PALO VERDE NUCLEAR GENERATING STATION, UNITS 1, 2, AND 3

REQUEST FOR ADDITIONAL INFORMATION REGARDING

RISK-INFORMED INSERVICE TESTING (R-IST) PILOT PLANT

COMANCHE PEAK STEAM ELECTRIC STATION, UNITS 1 AND 2

Figure 1

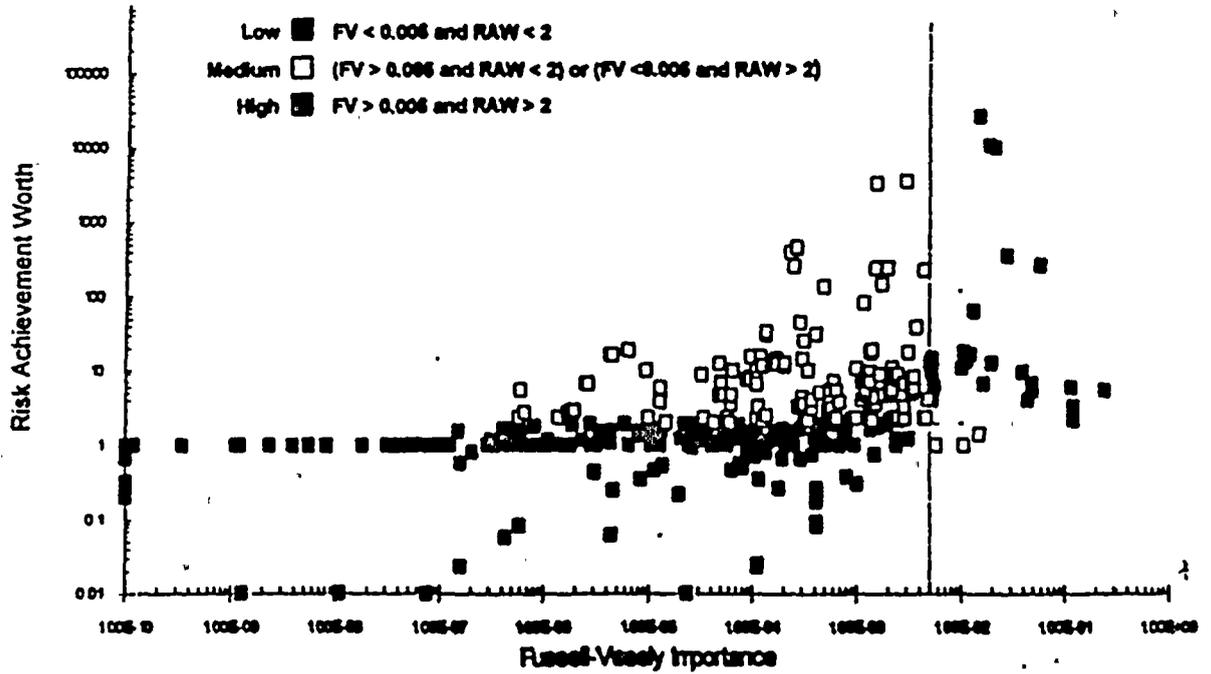
Another potential risk-ranking approach that we have given some consideration to is shown in the plot of Figure 2. Some typical basic event data are shown plotted as Fussell-Vesely importance ranking vs Birnbaum ranking. The data points are shown in some tentative quadrants, Hi-Hi, Lo-Lo, Hi-Lo, etc. Would the Expert Panel gain any useful insights by evaluating such a plot? Would it have any significant effect on the ranking results?
